**Walton County
The Grove**

**Change Proposal #16 –
Building J – Storage Room and
Tools Closet Framing Change**

114 - Building J - Storage Room and Tools Closet Room Framing Material Change

1 MAINTENANCE FACILITY FLOOR PLAN
A2.01J 1/4" = 1'-0"

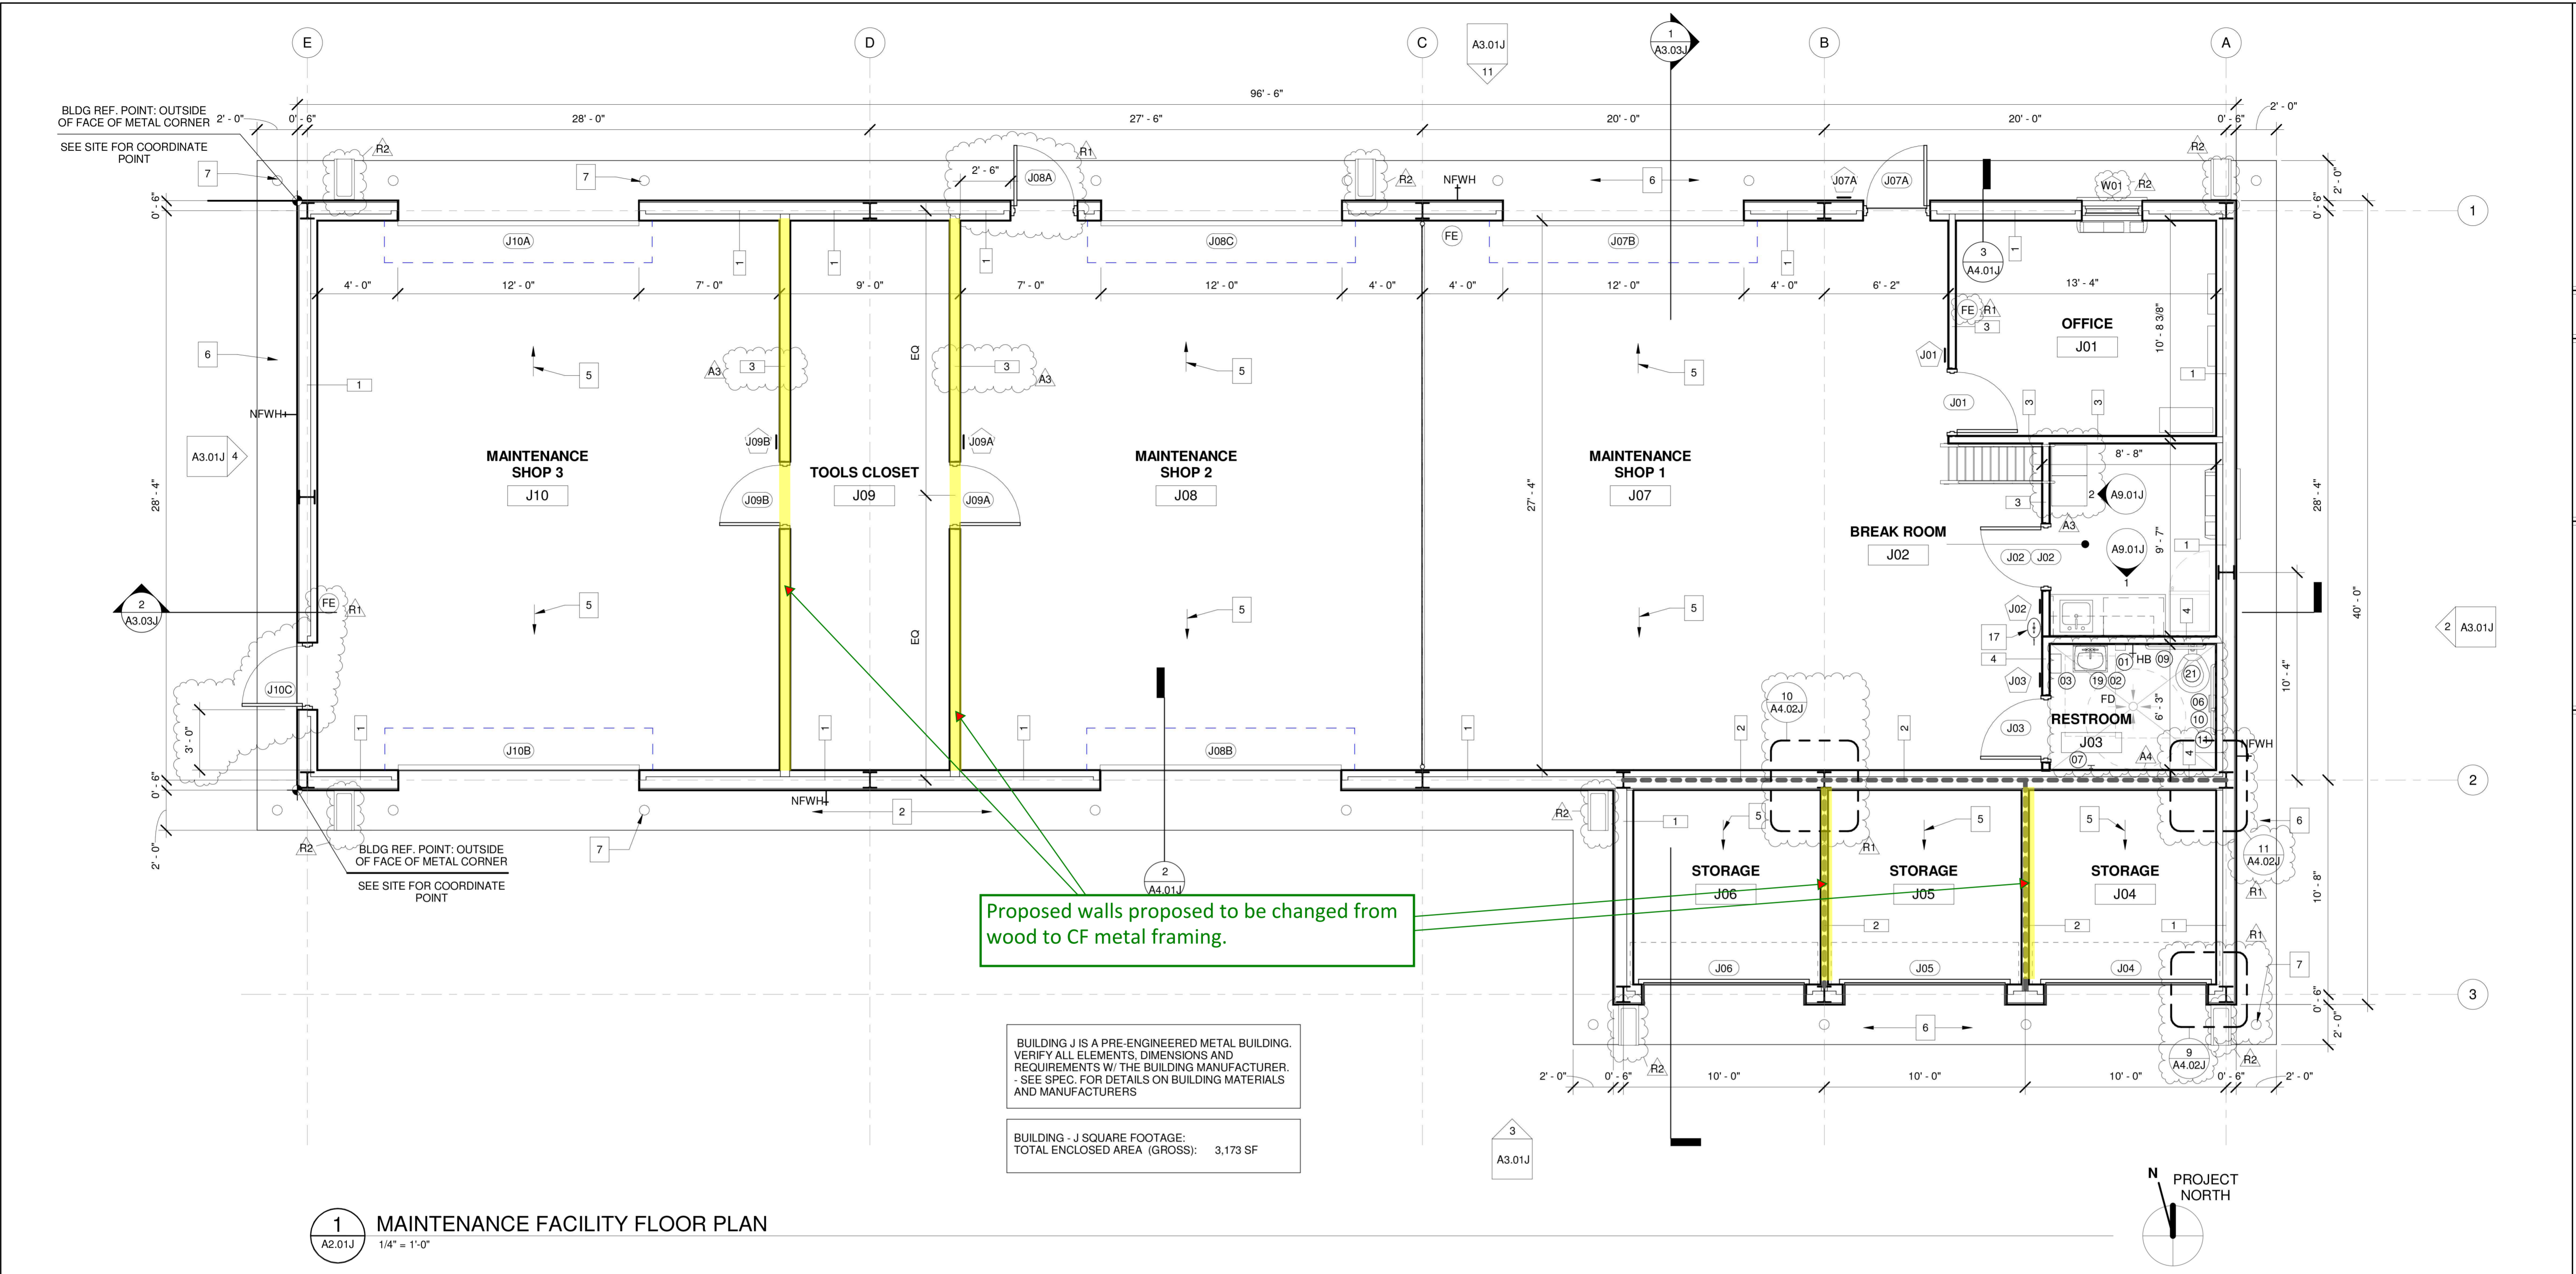
The below change proposal is for the material no cost change proposal to replace the wood framing to CF metal framing for the interior walls at the Storage Rooms (J06, J05, & J04) and Tools Closet room (J09). Please see the breakdown and supporting documentation for your reference.

During the last OAC meeting on 10/23/24, RY discussed with Lose and Ascension if it was acceptable at Building J, to replace the wood framing to CF metal framing for the interior walls at the Storage Rooms (J06, J05, & J04) and Tools Closet room (J09). The material framing change would not implement any cost impacts and would allow us to completely enclose the structural beams above without having to box them out. Lose and Ascension had no exceptions to the change.

Proposed walls proposed to be changed from wood to CF metal framing.

Lose Design and Ascension agree to switch the fire-rated walls to metal stud framing instead of 2x4 wood, as this change would allow for complete enclosure of the structural beams above without requiring additional boxing. This change is approved as long as it does not result in any additional cost.
